Re: **Application for Subdivision and Site Plan Review
Assessor's Map 210, Lot 02
200 Chase Drive
Altus Project #P4950**

At the October 1, 2019 Technical Advisory Committee (TAC) meeting, Altus Engineering presented the proposed Subdivision and Site Plan Review applications for the 200 Chase Drive on behalf of the Bethel Assembly of God and 200 Chase Drive, LLC. The TAC provided comments on the proposed design, which have since been addressed in the revised submittal package. The following written comments were provided by TAC with Altus' responses are below (in Red):

FIRST FLOOR SKETCH PLAN

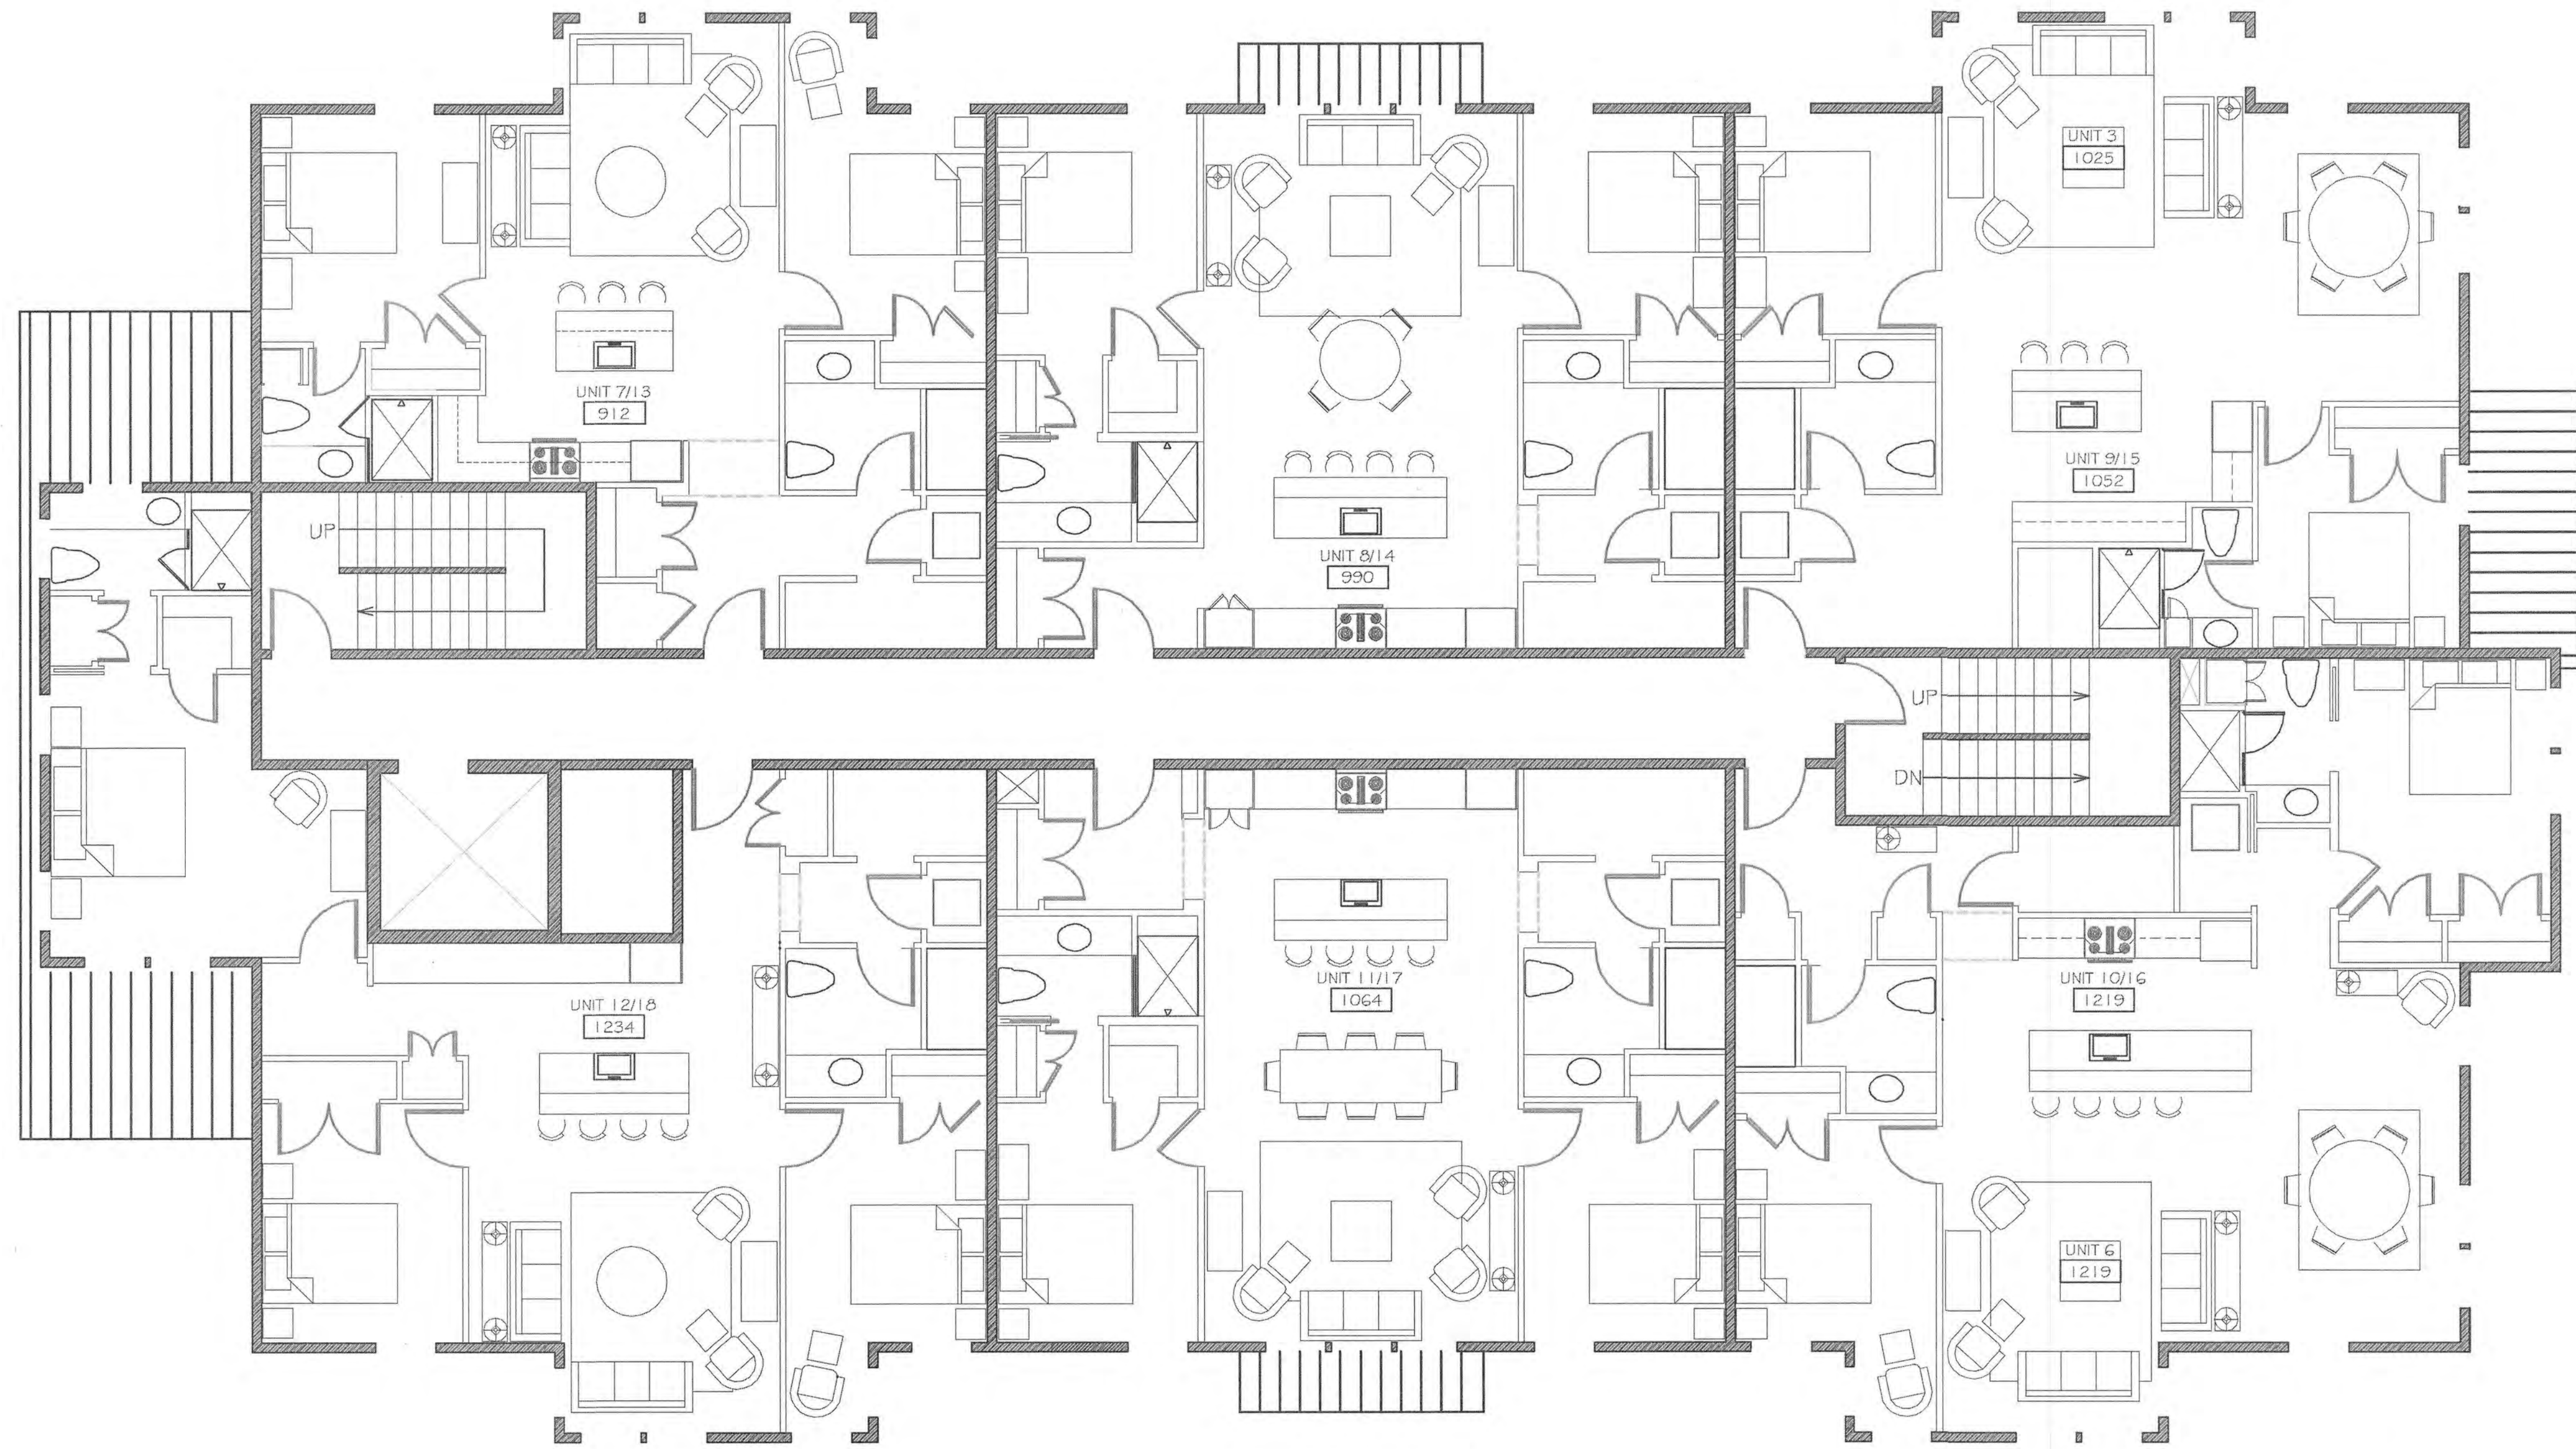
- *Apartment building: Where is the 2nd exit on the first floor?*
 - *The first floor plans have been revised to show exits at both the Market Street and Chase Drive sides of the building.*
